DESIGN <i>AB</i>	DRAWN BY <i>AB</i>	DART AEROSPACE LTD HAWKESBURY, ONTARIO, CANADA	
CHECKED <i>AB</i>	APPROVED <i>AB</i>	DRAWING NO. DSI 9357	REV. B SHEET 1 OF 2
DATE 06.12.05		TITLE CROSSTUBE SUPPORT CHANGE	SCALE NTS
	A	06.10.25	NEW ISSUE
	B	06.12.05	D2732-058 & MS21920-32 WERE D2182B058 & MS21920-30;ADD DSI KIT

DART SERVICE INSTRUCTION

TO AMEND INSTALLATION INSTRUCTIONS IIN-D212-664 Rev. C AND
INSTRUCTIONS FOR CONTINUOUS AIRWORTHINESS ICA-D212-664 Rev. 2

**FIGURE 1 – CROSSTUBE SUPPORT
INSTALLATION ON D412-664-203**

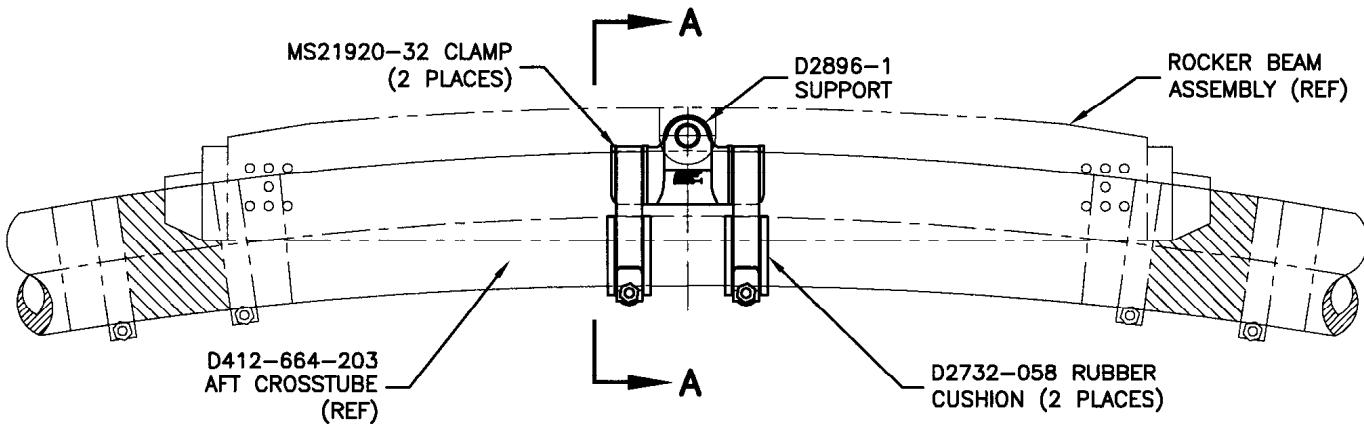
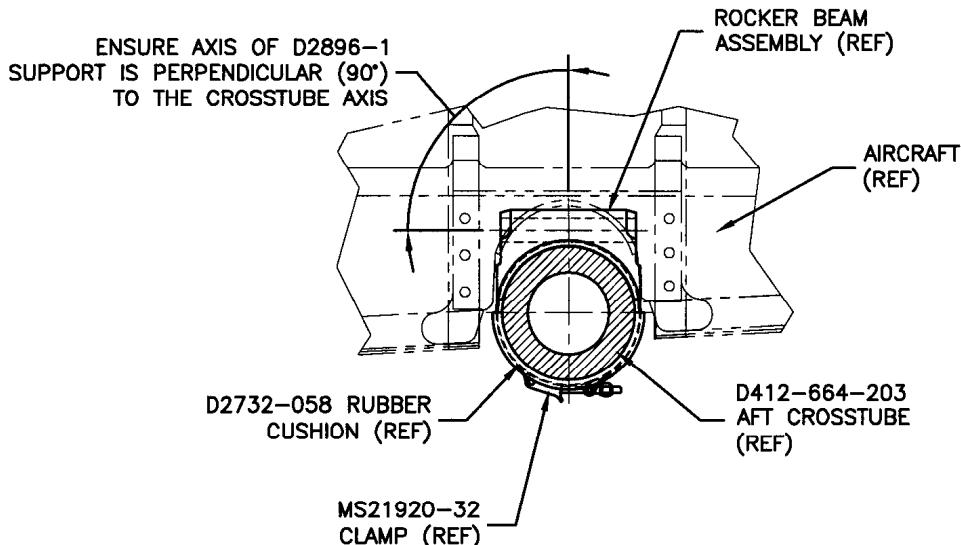
For D412-664-203 Aft Crosstubes at CHG 003 or later, the D2856-600-1087 Abrasion Strip has been removed, the center D2896-1 Support has been bonded onto the crosstubes using Magnobond 6398 and D2732-058 Rubber Cushions have been installed underneath the MS21920-32 Clamps. Amend Parts List of IIN-D212-664 Section 5 and ICA-D212-664 Section 32.8 as follows:

To prevent the center support from shifting on D412-664-203 Crosstubes at CHG 001, the D2896-1 Support should be removed and re-installed as follows:

- 5) Apply a 0.03" to 0.06" thick layer of Magnobond 6398 underneath D2896-1 Support and re-install the Support on the crosstube as shown in Figure 1. Use rocker beam assembly to properly align the D2896-1 Support. Ensure the Rocker Beam Assembly can move freely without any friction with other parts. Install a D2732-058 Rubber Cushion on each MS21920-32 Clamp. Position and secure the D2896-1 Support on the crosstube using MS21920-32 Clamps. Torque clamps 80-100 in-lb. Let the D412-664-203 Crosstube Assembly cure before re-installing the crosstube on the aircraft.
